Detailed Site Plan
Departure from Design Standards
Departure from Sign Design Standards
Laurel Hospital Property

DSP-19049
DDS-667
DSDS-707

SUBJECT: Detailed Site Plan DSP-19049
Departure from Design Standards DDS-667
Departure from Sign Design Standards DSDS-707
Type 2 Tree Conservation Plan TCP2-031-09-02
Laurel Hospital Property

Figure 4: Signage Examples

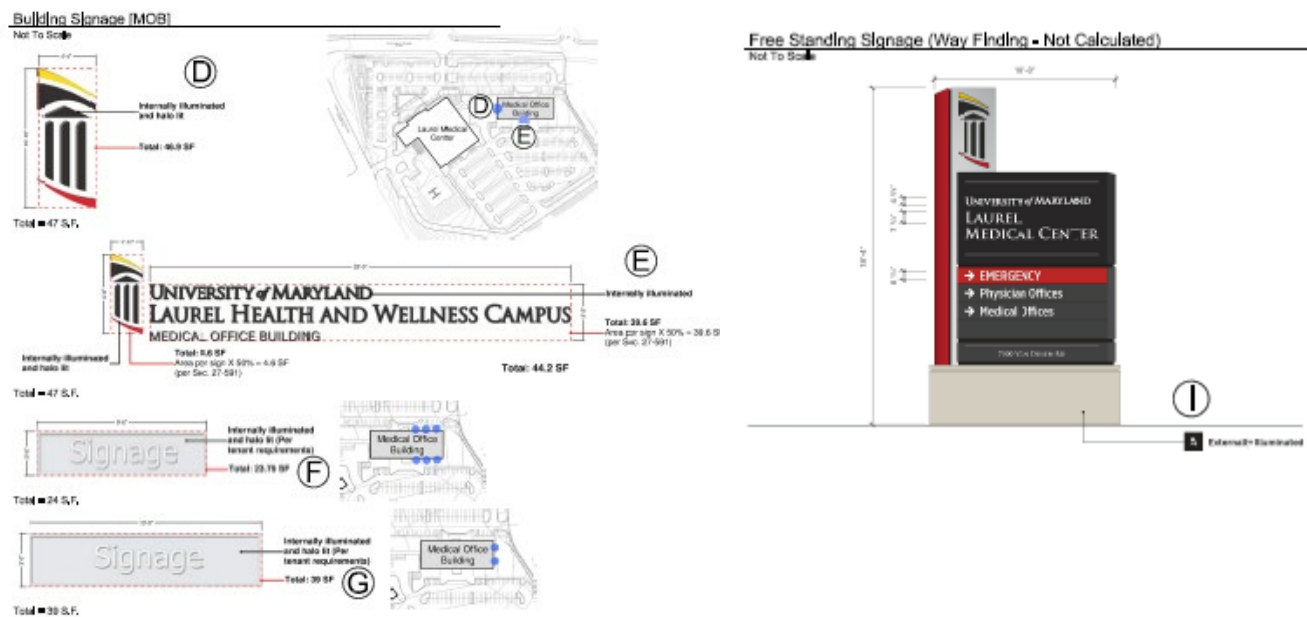
Each proposed, building-mounted sign is less than 48 square feet. Individual freestanding and monument sign areas are shown in the departure request as 48 square feet or less. However, the area for freestanding signs is not identified on the DSP and appears to be much greater than 48 square feet. The sign calculations table provided on the DSP should be corrected to reflect individual area of each of the 17 signs provided. Staff has included a condition in the Recommendations section for this detail to be included on plans.

Three freestanding signs are proposed to be approximately 18.5 feet in height above finished grade at the base of signs. The site identification monument sign is proposed to be slightly greater than 14 feet in height above finished grade at the base of the sign. Signage is not shown on architectural elevations for either building. Therefore, staff has included a condition in the Recommendation section for the DSP to be revised to identify signage locations on the architectural elevations.

Under this provision, a total of two signs would be allowed, as the property fronts on two streets. A total of 17 signs are proposed for both the freestanding medical facility and medical office building. Three freestanding signs are proposed, one each at site access point off of Contee Road, and one at the entrance off of Van Dusen Road. A fourth, freestanding, monument, identity sign is proposed at the corner of Contee and Van Dusen Roads. For both buildings, a total of 13 building-mounted signs are proposed. These include University of Maryland Medical Center identity signs, identity signage for service areas, such as the emergency department, and tenant identity signage for the medical office building.

- b. Correct DSP Sheet 7, Sign Calculations table to remove the institutional sign design standards and to provide the area and height figures for each sign proposed. Further correct the Sign Calculations table to show the correct approved departure.

- e. Revise the architectural elevations for the freestanding medical facility and medical office buildings to show signage placement for all building-mounted signage.
